### **Thanet Extension Offshore Wind Farm**

Annex B to Appendix 15 to Deadline 6 Submission:  
Responses to Natural England on the potential  
sand wave clearance and displacement of material  
from Goodwin Sands pMCZ

Submitted by Vattenfall Wind Power Ltd

Date: May 2019

Figure 2.11: Sediment Transport Pathways Across the Marine Physical Processes Study Area

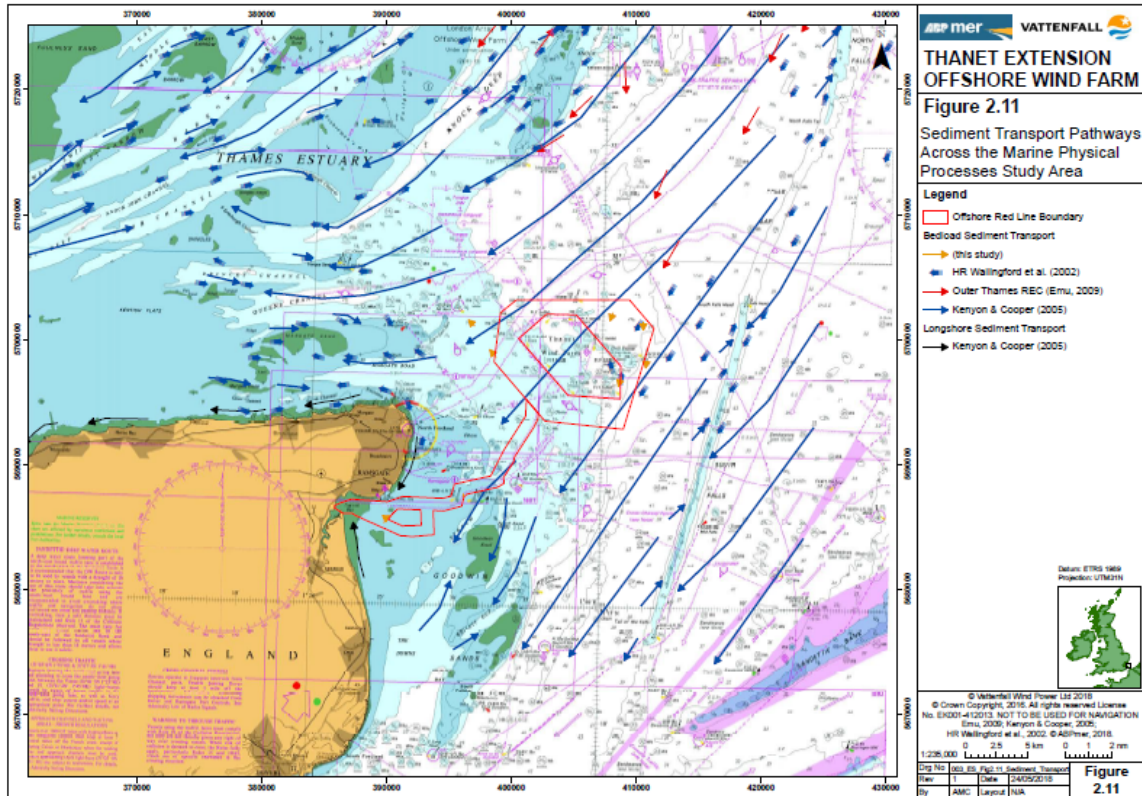
- 3 Natural England requested further information on the likelihood of sediment retention within Goodwin Sands pMCZ (primarily direction of sediment transport in the vicinity) and the potential volume of sediment which could be required for disposal from sand wave clearance in the Goodwin Sands pMCZ.

- 6 Natural England highlighted this may lead to a loss of sediment and asked for confirmation that any sediment disposed of within 500 m of the Goodwin Sands pMCZ would be retained within the site through natural processes, i.e. not lost from the MCZ system. This note also identifies that the sediment is likely to be retained within the wider Goodwin Sands system, if not the pMCZ, as is demonstrated by the presence of Goodwin Knoll and the sand banks present. This note also seeks to provide the requested clarification and further evidence to compliment Appendix 32 of the Applicant's Deadline 5 Submission and to confirm that this would be the case.

- 8 As presented in in paragraph 2.7.49 and Figure 2.11 of the physical processes chapter there is a regional net south-westerly bed load transport in the Offshore Export Cable Corridor (OECC) including where the intersection of Goodwin Sands pMCZ is present. Therefore, sediment disposed of within 500 m of the Goodwin Sands pMCZ is anticipated in follow the broadscale patterns and be transported south and into the pMCZ site.

- 9 A convergence of sediment transport is created to the south of the OECC and the south-west of Goodwin Knoll, as presented in Figure 2.11 (of the ES chapter). This convergence, in the northern end of the Goodwin sandbank system is likely to result in localised variation of sediment transport, as indicated by the asymmetry of individual bedforms in the area, in both spatial (net bed load direction) and temporal scales (e.g. seasonal, inter-annual, or decadal). The precise location of this convergence, whilst hard to define, is likely to be to the south of the area of the OECC. The presence of the convergence, and the likelihood therefore of sediment being retained within the convergence of sediment transport pathways, is considered likely to result in material that is disposed of within 500 m of the pMCZ being retained within the Goodwin Sands pMCZ system following its transport back into the site by the bed load transport.

- 12 As presented in Figure 2.11 the sand waves in the area of interest were defined as small to medium sand waves. As described in paragraph 2.7.56 of the physical processes chapter, the sand waves present through the OECC are smaller than the features present within the array.

- 19 Following the Applicant's commitment to dispose of sediment within 500 m of Goodwin Sands pMCZ coupled with the net south westerly transport of the bedload; there would not be a net 'loss' of sediment from the Goodwin Sands pMCZ. Therefore, it is the Applicant's position that this commitment is appropriate and addresses Natural England's concerns raised regarding a loss of material from the site.
